From: BRYAN Martin (EXT) [Martin.Bryan.ext@areva.com]
Sent: Wednesday, June 09, 2010 5:32 PM
To: Tesfaye, Getachew
Cc: DELANO Karen V (AREVA NP INC); ROMINE Judy (AREVA NP INC); BENNETT Kathy A (OFR) (AREVA NP INC); GUCWA Len T (EXT)
Subject: Response to U.S. EPR Design Certification Application RAI No. 368, FSAR Ch 6, Supplement 1, Part 1 of 5
Attachments: RAI 368 Supplement 1 US EPR DC Part 1 of 5.pdf

Response to
Request for Additional Information No. 368, Supplement 1

U. S. EPR Standard Design Certification
AREVA NP Inc.
Docket No. 52-020
SRP Section: 06.02.01 - Containment Functional Design
Application Section: 06.02.01

**Figure 06.02.01-59-1—Flow Patterns in the Reactor Vessel Before LHSI
Realignment**

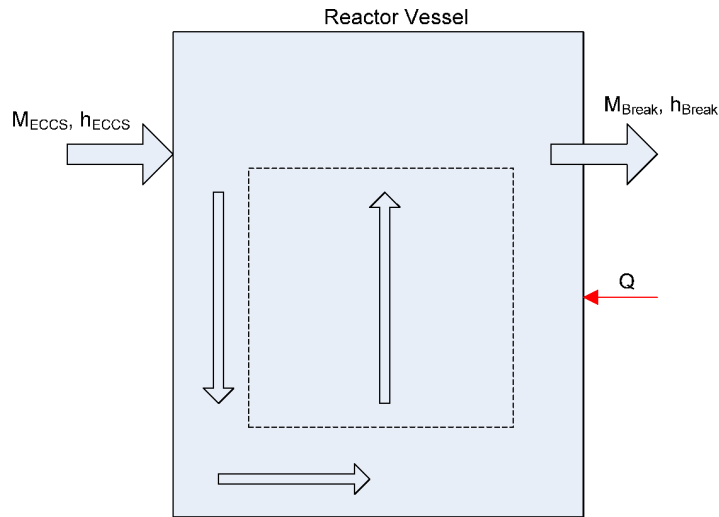
The response to RAI 221 06.02.01-46 states that for hot leg breaks the ECCS configuration in Technical Report ANP-10299P, Section 8.1.4, will be modified to incorporate the impact of the transition to hot leg injection, which will result in a reduction of pumped ECCS to the cold legs. The ECCS configuration in the hot leg break scenario will consider that ECCS will be aligned to the hot legs at 3600 seconds and spill out the break; only the medium head safety injection (MHSI) and a portion of the low head safety injection (LHSI) will be delivered to the cold legs for core cooling. When will these modifications to ANP-10299P be done and presented to the staff? What are assumptions for the hot leg injection water after it spills from the break? Does it mix in the containment atmosphere or is it spilled on the containment floor? Is this done in RELAP5-BW or in GOTHIC portion of the mass and energy release analysis?

Figure 06.02.01-59-1 shows the flow pattern in the reactor vessel before low head safety injection (LHSI) realignment. The mass and energy balance equations during this phase are:

After hot leg injection, a portion of the LHSI is realigned for hot leg injection. The LHSI injected to the hot legs is assumed to bypass the core and flow back directly to in-containment refueling water storage tank (IRWST) without mixing in the containment atmosphere or spilling on the containment floor. This is done in the GOTHIC portion of the mass and energy release analysis. In the GOTHIC model, the LHSI injected in to the hot legs is lumped together with the LHSI recirculation flow and returned to IRWST. The available ECCS water for the core cooling during this phase is the medium head safety injection (MHSI) and the remaining LHSI delivered to the cold legs. Figure 06.02.01-59-2 shows the GOTHIC model after LHSI realignment.
